**To: All Vendors Bidding on The College of New Jersey  
Baseball Field Irrigation System Project**

**ADDENDUM NO. 1**

**REFERENCE:** The College of New Jersey  
Baseball Field Irrigation System  
Bid No. AB160041

DRAINAGE PLAN 1"=60'-0"

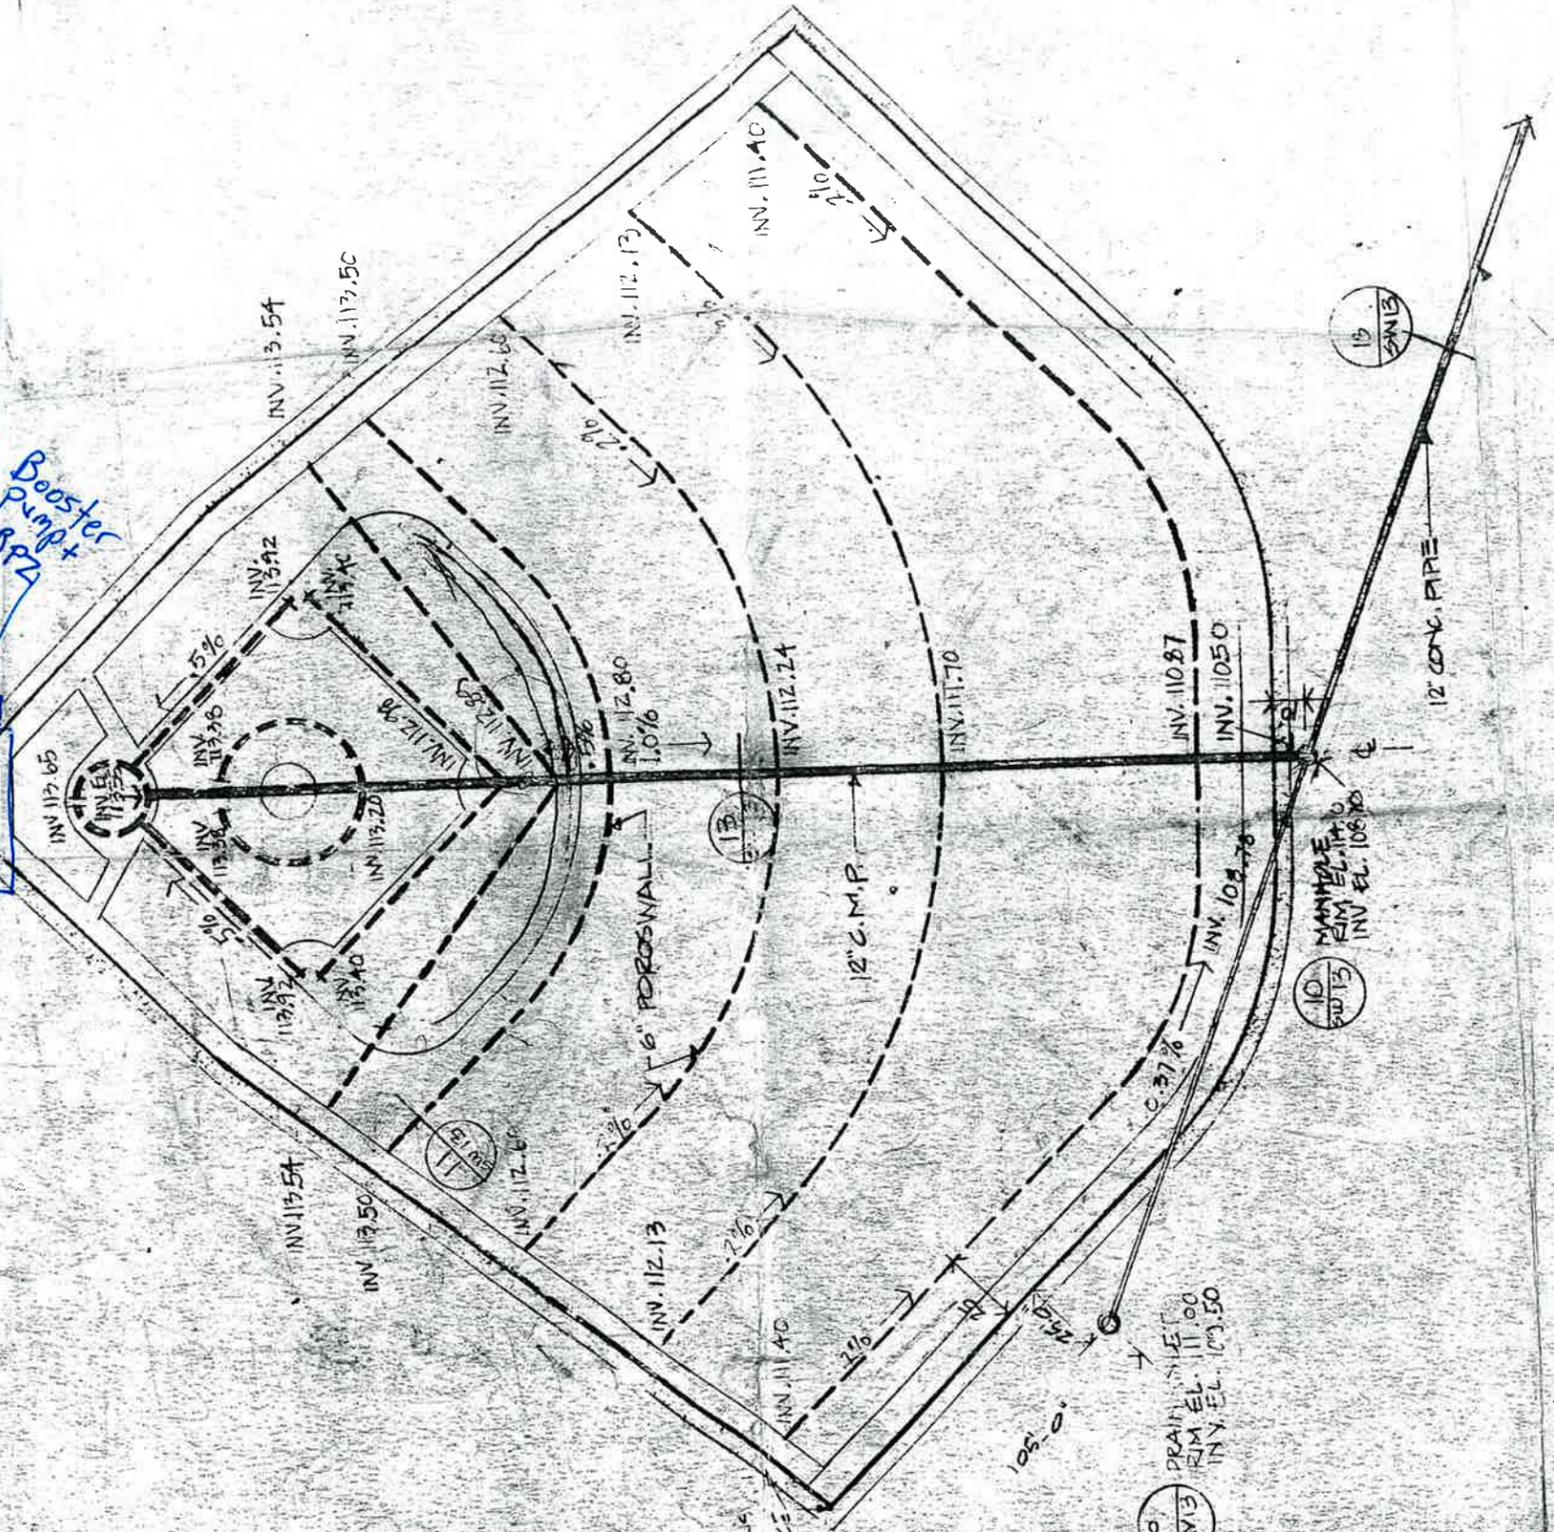
Question: Do you have a utility plan for the existing field drainage and power to the score board?

Question: Where will the pump be located?

Question: What is the water source? The current backflow is piped with plastic.

Response: See attached PDF for field drains. TCNJ to have all utilities marked out prior to construction.

Response: See attached PDF.

Response: The water source is a 3" cast iron main located 25' from the proposed location of the booster pump. Main is 10' deep. Contractor will be responsible for tying into main water line. See attached PDF.
